June 26, 2023

**Re: *Planning Addendum Letter, Resubmission 1***  
***Application No. 22 180913 NNY 16 OZ***  
***895 Lawrence Avenue East (the “subject site”)***

The following section provides responses to the comments received by Planning and urban Design dated February 27, 2023:

Figure 1, North York Official Plan (1998) Land Use Plan

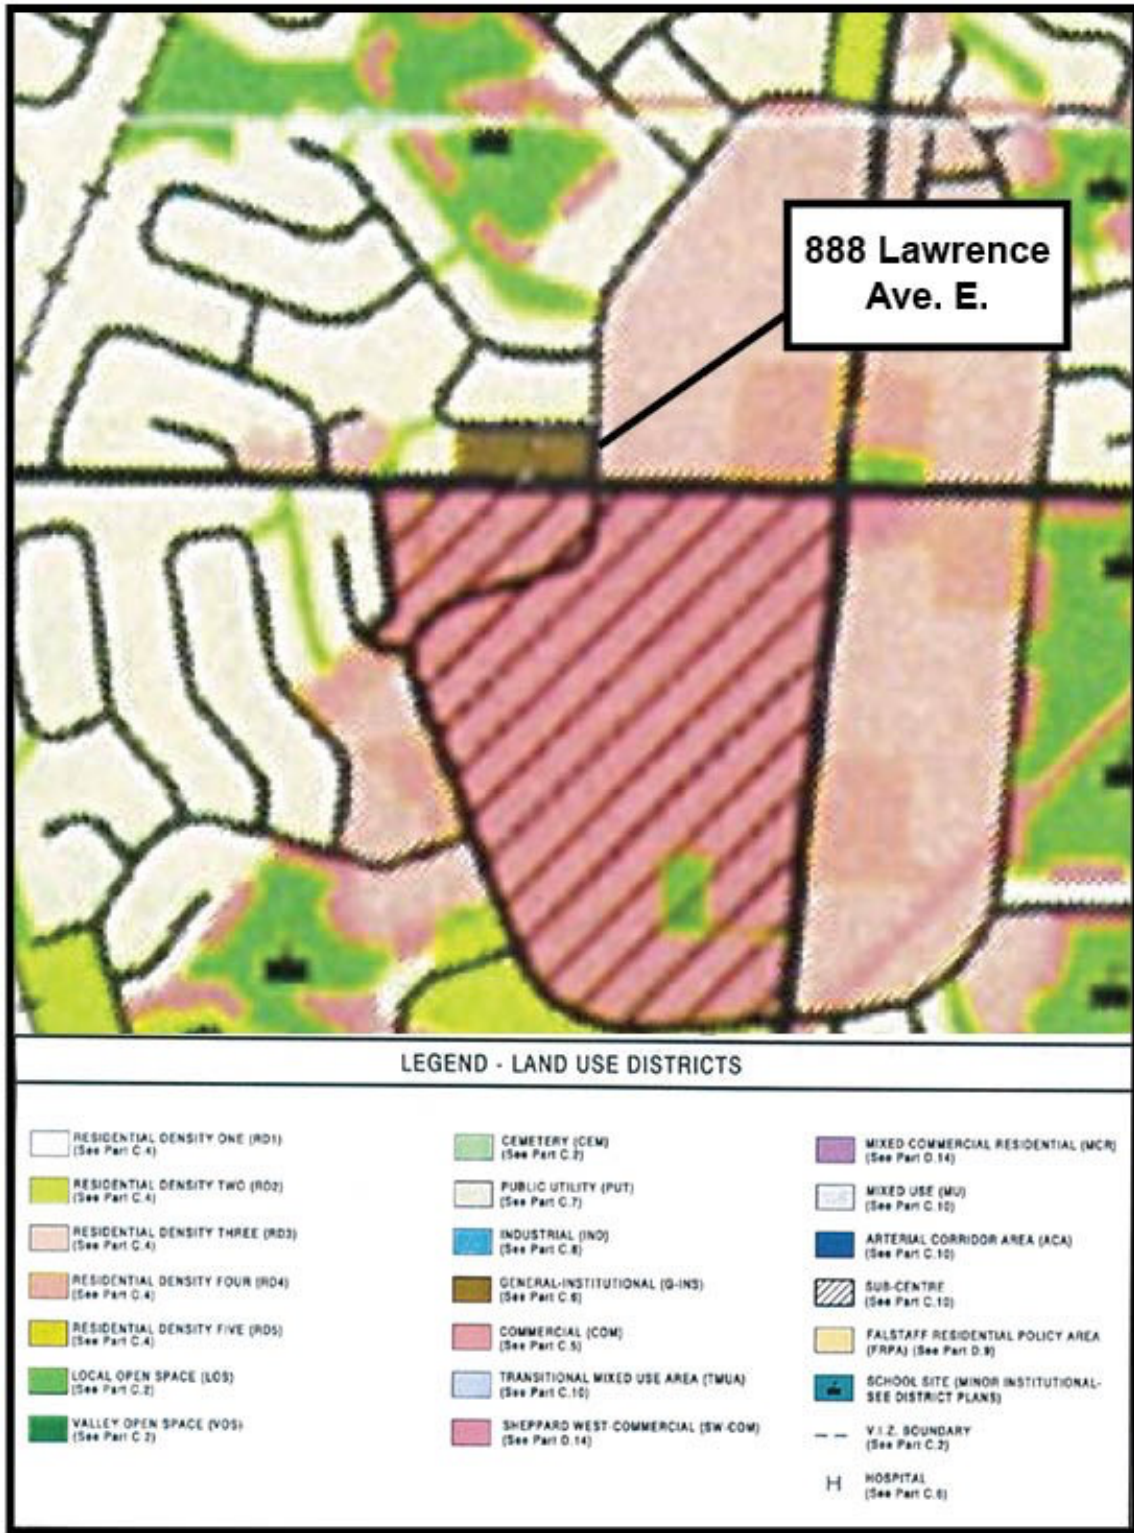
The City's OP and Tall Buildings Guidelines (TBG) encourage new development to provide appropriate transition in scale and density to areas of different development intensity. This transition is especially encouraged for new development in Mixed Use.

While the lands located on the north side of Lawrence Avenue East are designated *Neighbourhoods* in the City of Toronto Official Plan (2006), they are occupied by an institutional use in the form of Toronto Public Library Don Mills Branch. This institution has existed at this address (888 Lawrence Avenue East) since it was built in 1961. To that end, this property was originally planned for an institutional use in the former City of North York Official Plan, which is evident in its most recent 1998 consolidation. Specifically, Map C1 (North York Official Plan Land Use Plan) identifies 888 Lawrence Avenue East as within the *General Institutional* land use designation, which permitted institutional uses such as libraries, but it did not permit residential uses (see **Figure 1** below).

In particular, Section C.6 2.1.0 of the former City of North York Official Plan states that “institutions that serve the local community shall generally be permitted on lands designated for residential, industrial, commercial, mixed use and general institutional use”. However, 888 Lawrence Avenue East was intentionally designated *General Institutional* as the Don Mills Branch library is identified as a regional institution rather than a local institution.

Figure 3, Angular Plane to Relevant Property Line

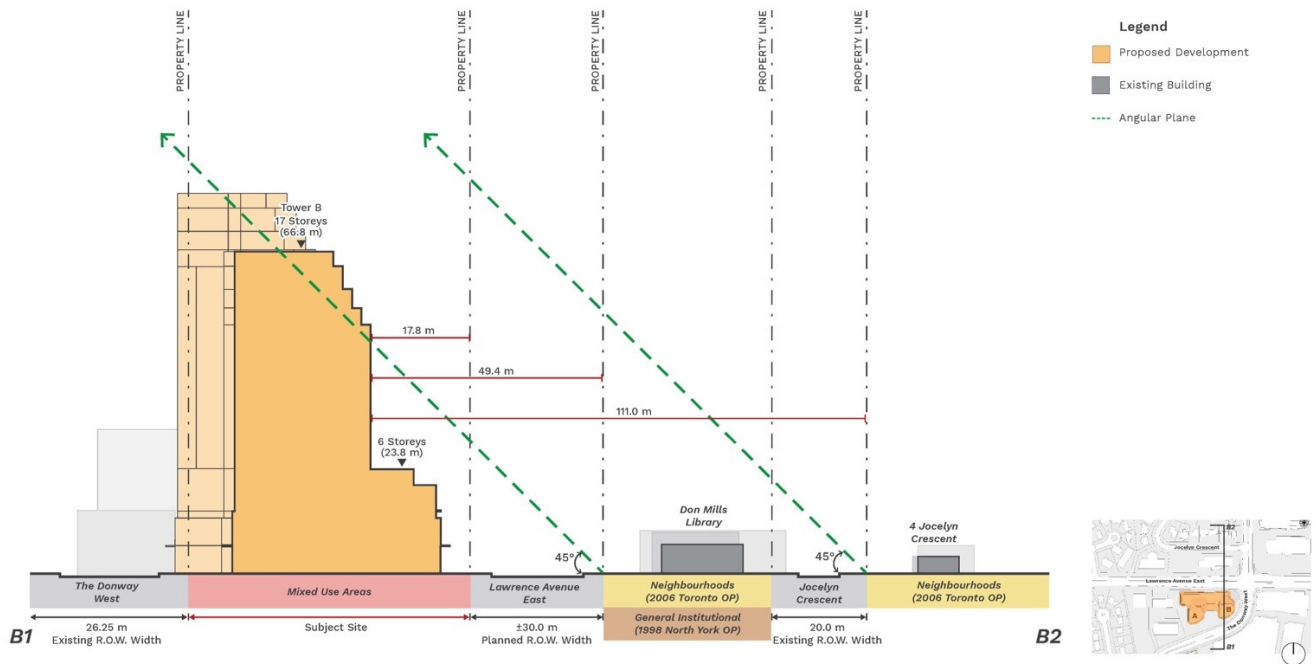
The submitted materials indicate that the proposed towers pierce through the angular plane from the Neighbourhoods designation to the north. While a tall building may be considerable for the site, the towers should not pierce the angular plane as proposed. Reduction in height is strongly encouraged.

We have prepared the following angular plane diagram to illustrate that applying a 45 degree angular plane from the north side of Jocelyn Crescent meets the intent of the former City of North York Official Plan (1998), the City of Toronto Official Plan (2006)

and the Tall Building Design Guidelines. Specifically, the north side of Jocelyn Crescent is the relevant property line, and not the north side of Lawrence Avenue East. **Figure 3** below illustrates the following:

1. The north side of Lawrence Avenue East contains a regional institutional building (Don Mills Library Branch);
2. The closest low-rise dwellings within the *Neighbourhoods* designation are located on the north side of Jocelyn Crescent;
3. The north side of Jocelyn Crescent 111.0 metres north of the closest proposed tower;
4. The relevant property line is located on the north side of Jocelyn Crescent; and
5. The proposed towers fall well within a 45-degree angular plane measured to the relevant property line.

The 45-degree angular plane is a guideline that is intended to adequately limit built form impacts, and to achieve the appropriate transition to the surrounding low-rise residential context. In our opinion, the revised proposal meets the primary intention of this guideline through the use of setbacks, stepbacks and the height allocation of the proposed towers. Based on the above analysis, it is our opinion that measuring the angular plane from the north side of Jocelyn Crescent is the most appropriate location, given the existing use at 888 Lawrence Avenue East and the historical context of the property.

*Figure 4, Angular Plane Tent Diagram*

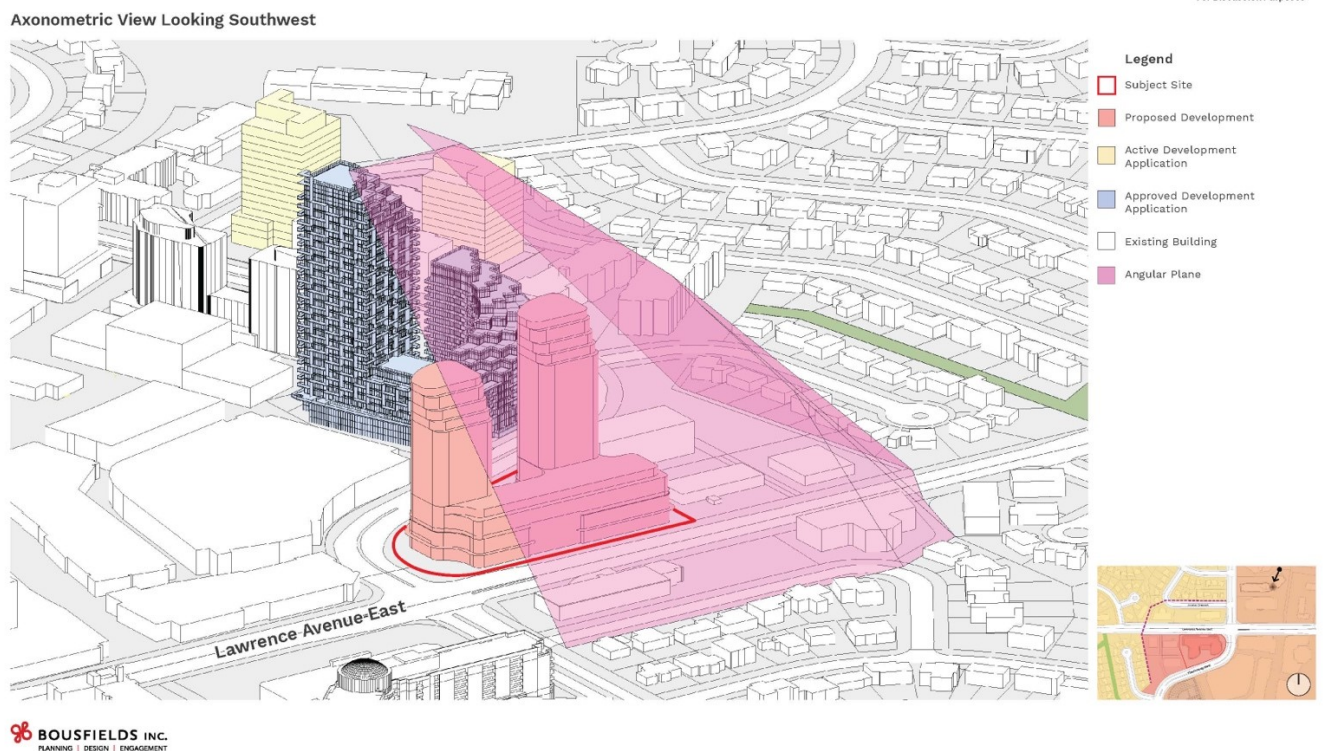
It is further noted that future submission materials shall use the appropriate angular plane (i.e. 45 degrees from the Neighbourhoods designation as opposed to a mid-rise angular plane) and that the angular plane should extend across the site to clearly illustrate where it intersects with the towers, should any intersection occur.

As illustrated on **Figure 3** above, all proposed building elements fall wholly within a 45 degree angular plane from the relevant property line. Bousfields Inc. has also prepared an angular plane tent diagram to illustrate that all proposed building elements fall wholly within a 45 degree angular plane tent from the closest existing and planned low-rise residential neighbourhoods to the north and west (see **Figure 4** below).

Bousfields Inc. has prepared a comprehensive Angular Plane Analysis to accompany this Planning Addendum letter, which is enclosed with this letter as **Appendix A**.
